Re: Edward Gonzales Elementary School Ph II, 554 90th St SW,
Request for Permanent C.O. –Accepted
Engineer's Stamp dated: 010-19-06, (L09/D034)
Certification dated: 10-04-12

**COMPOSITE DRAINAGE PLAN
PHASE 1 AND 2
EDWARD GONZALES ELEMENTARY SCHOOL**

ENGINEER'S DRAINAGE CERTIFICATION FOR PERMANENT CERTIFICATE OF OCCUPANCY -

EDWARD GONZALES ELEMENTARY SCHOOL
PHASES 1 AND 2
COMPOSITE DRAINAGE PLAN

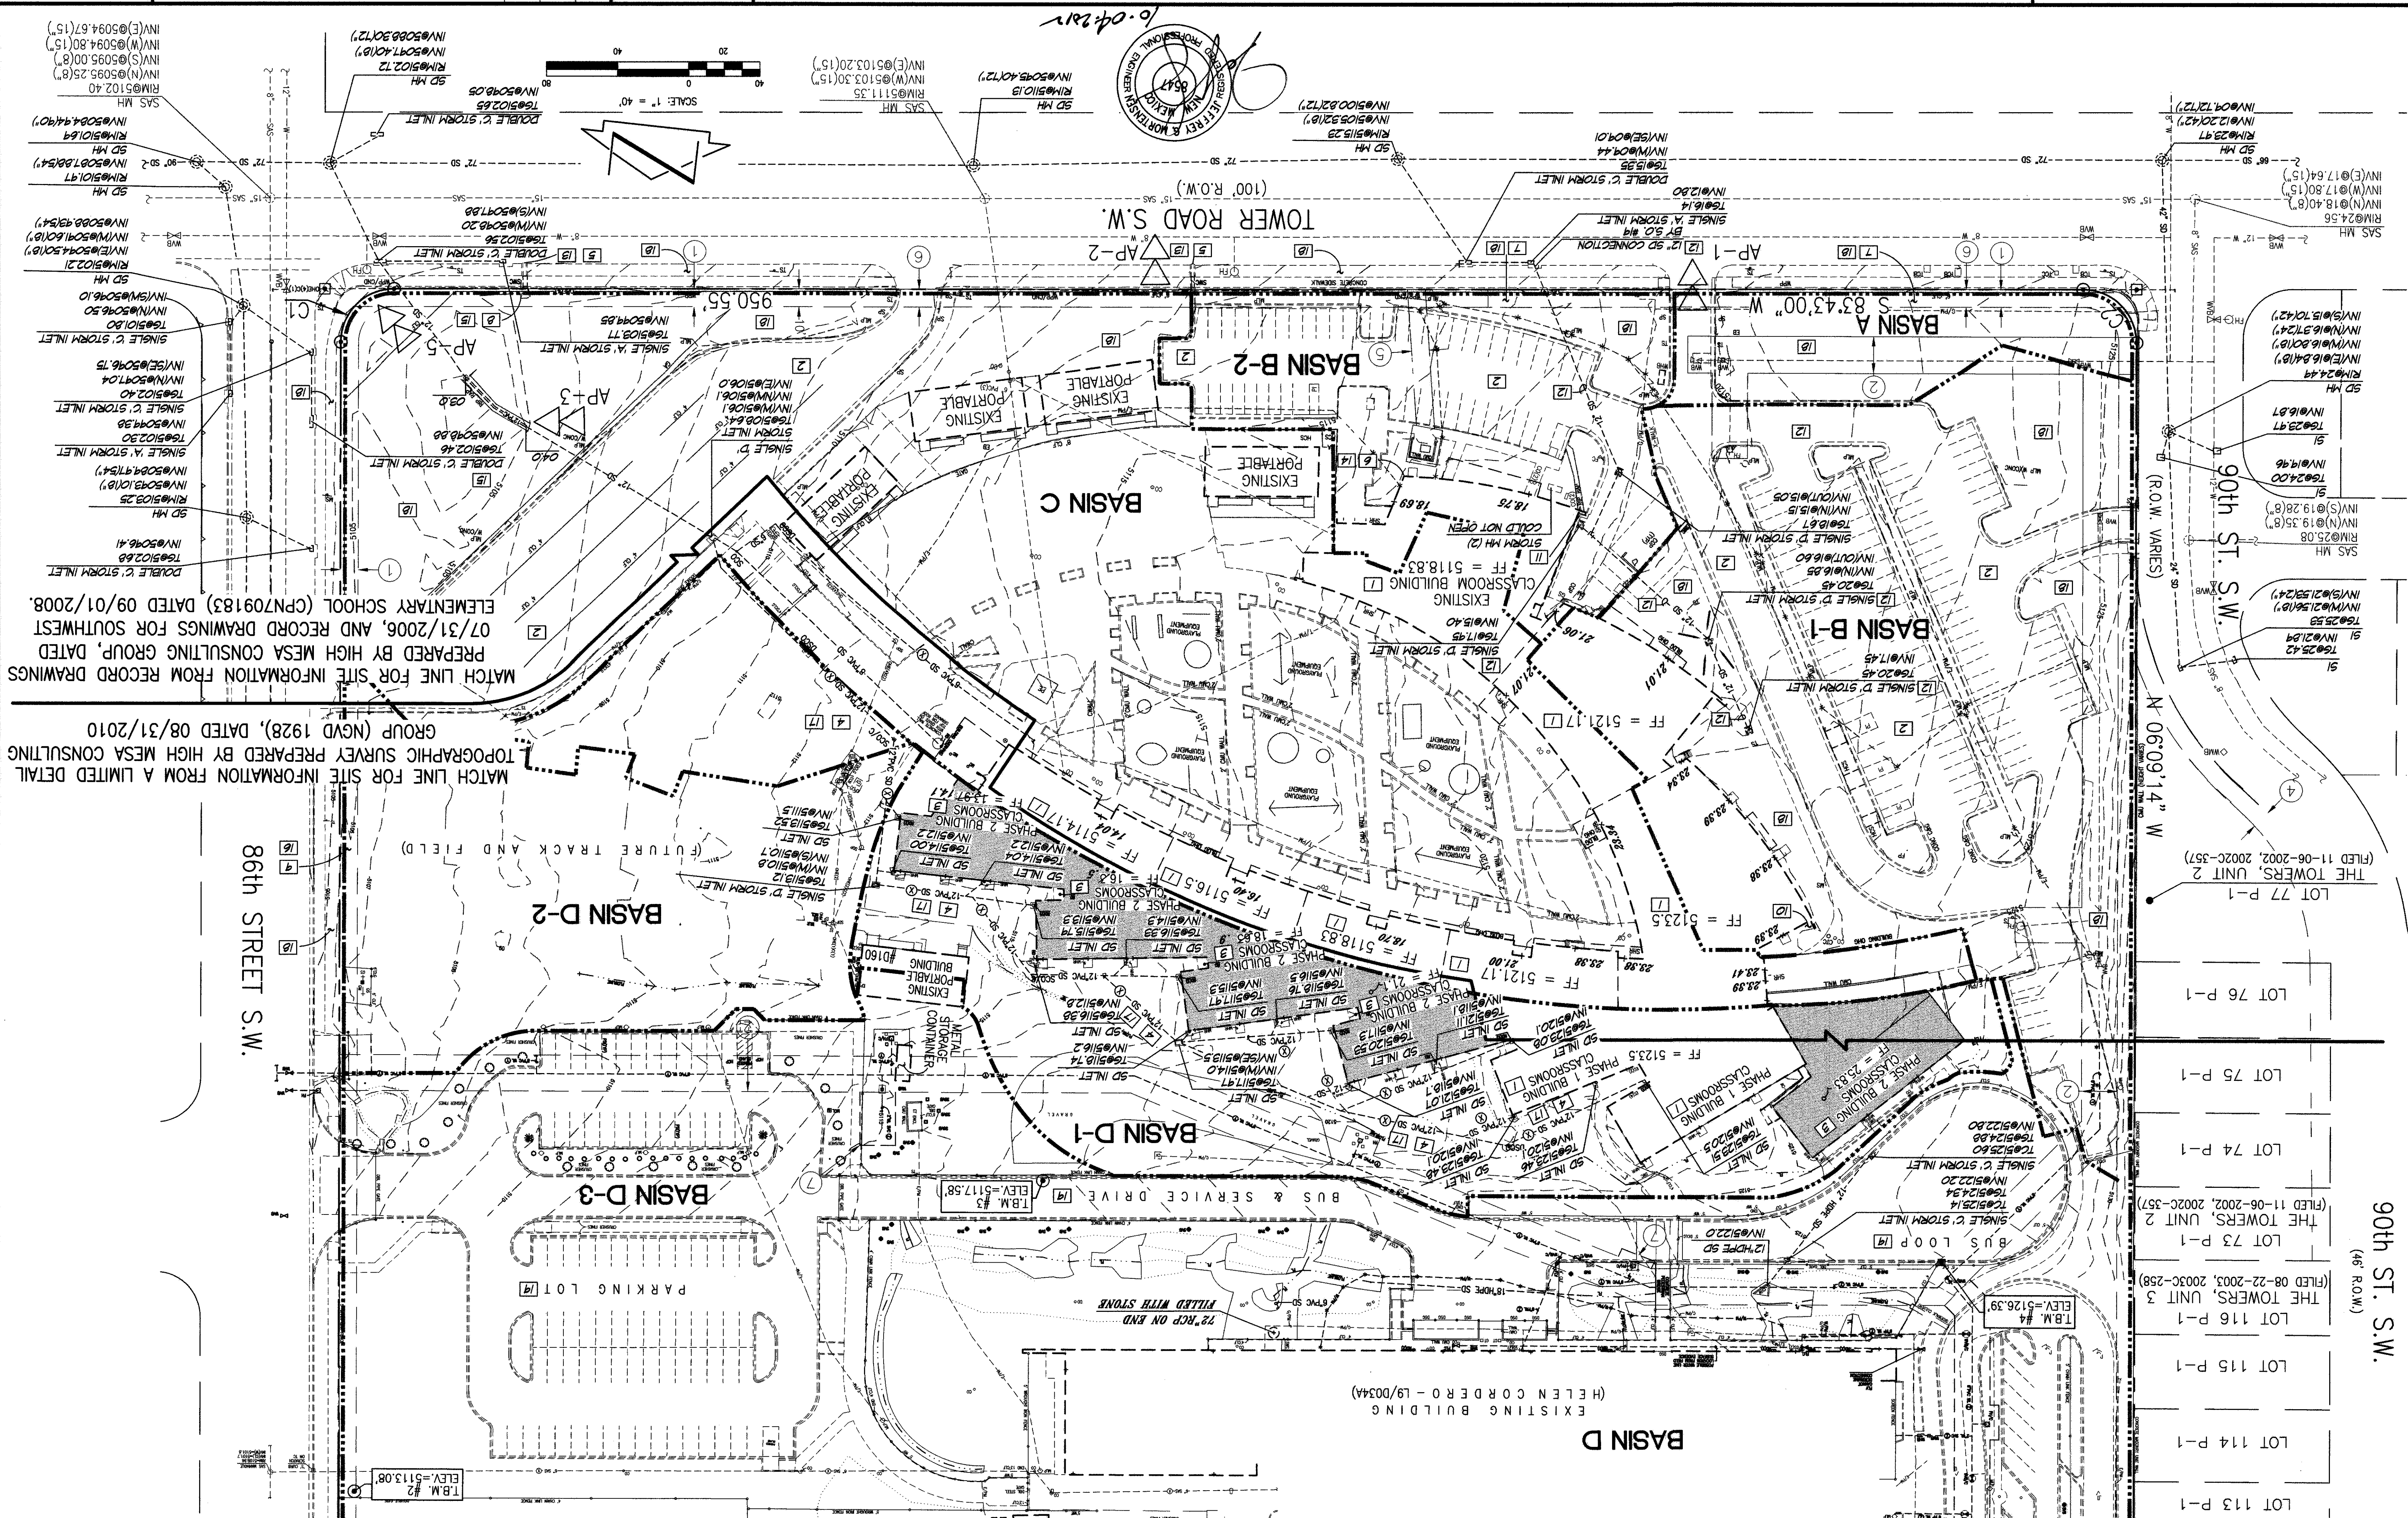
Based upon the information provided in the Certification received 10-04-13, the above referenced Certification is acceptable for a release of a Permanent Certificate of Occupancy by Hydrology.
